PRODUCT/PROCESS CHANGE NOTICE (PCN)

PCN #: L-0607-01R1 Product Affected: Please see the attached list of the affected products shipped in tape and reel, and in tubes Date Effective: 6-Oct-06	DATE: 6-Oct-06	MEANS OF DISTINGUISHING CHANGED DEVICES: <input type="checkbox"/> Product Mark <input type="checkbox"/> Back Mark <input checked="" type="checkbox"/> Date Code <input type="checkbox"/> Other Lot shipments will have Level 1 Moisture Sensitive Label, and with date code starting "0630".
---	-----------------------	---

ATTACHMENT 1 - PCN #: L-0607-01R1

PCN Type: Change in Moisture Sensitivity Level

From: MSL 3 Moisture Sensitive Label

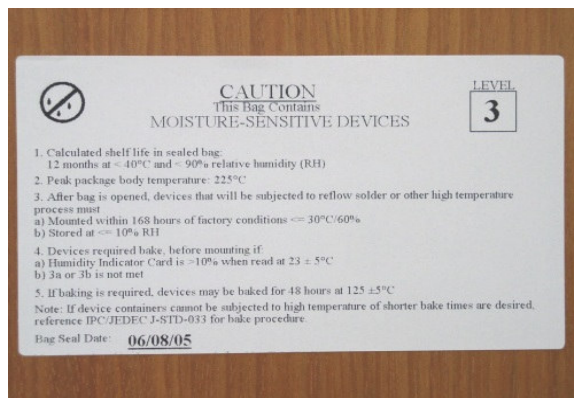
This notification is to advise customers that IDT is converting ICS MSL 3 products shipped in tape and reel, and in tubes, to MSL 1. IDT has completed the verification of the moisture sensitivity classification of ICS products to MSL 1.

The affected products will be shipped without dry pack and labelled as MSL 1 according the JEDEC J-STD-033. There is no change to the assembly material set and the peak reflow temperature. Please refer below for the examples of moisture sensitive labels.

To: MSL 1 Non-Moisture Label

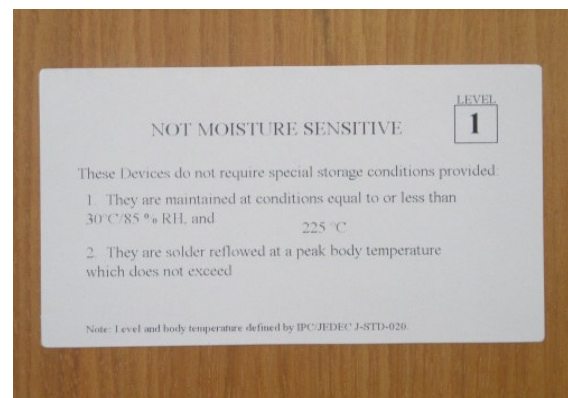
Note: There is no change to the peak reflow temperature of the affected products.
